# Poverty Flats Appeal Chapter 7: Hydrology & Water Supply

Section A: Project's Inadequate Groundwater Analysis, Fair Argument – Substantial Evidence of Limited Water Supply in High Valley

Figure 20: Within a one-mile radius, there are zero pending [green dots] and one approved projects (sic) [yellow dots]

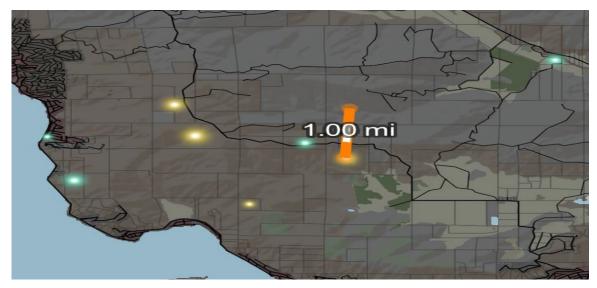
- Missing data from tally of area cannabis projects. The tally does not provide number of wells per project, well depth, well yield, estimated project water usage, evidence of sufficient groundwater supply for the project, and actual water usage (for approved projects). A true understanding of the project's cumulative impact on groundwater supply is not possible without these data.

**High Valley Basin and Wells as of 2016** [Source: EBA Brassfield Groundwater Availability Study, 2016]

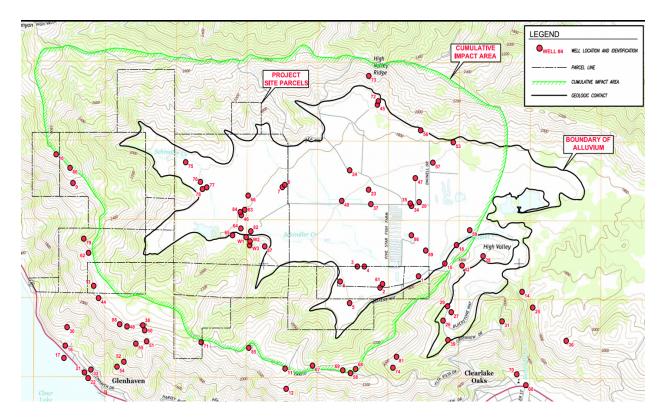
- ♦ High Valley Oaks: 6.6 AFY (acre feet/year)
- ♦ Liu Farms: 7.86 AFY
- ♦ Monte Cristo: 36.5 AFY
- ♦ Lemon Glow: 33.4 AFY to 45.8 AFY
- Brassfield Estate Vineyards: 260.70 AFY in 2016, planned to increase to 378.70 AFY
   [H7]
- Multiple residential wells
- Additional cannabis projects pending
- Cumulative High Valley Groundwater Demand. In High Valley, the combined water demand of Poverty Flats, High Valley Oaks, Liu Farms, Monte Cristo, and Lemon Glow is approximately 345.06 to 468.86 AFY. Localized drawdown risks are unaddressed. The CEQA analysis is therefore deficient.
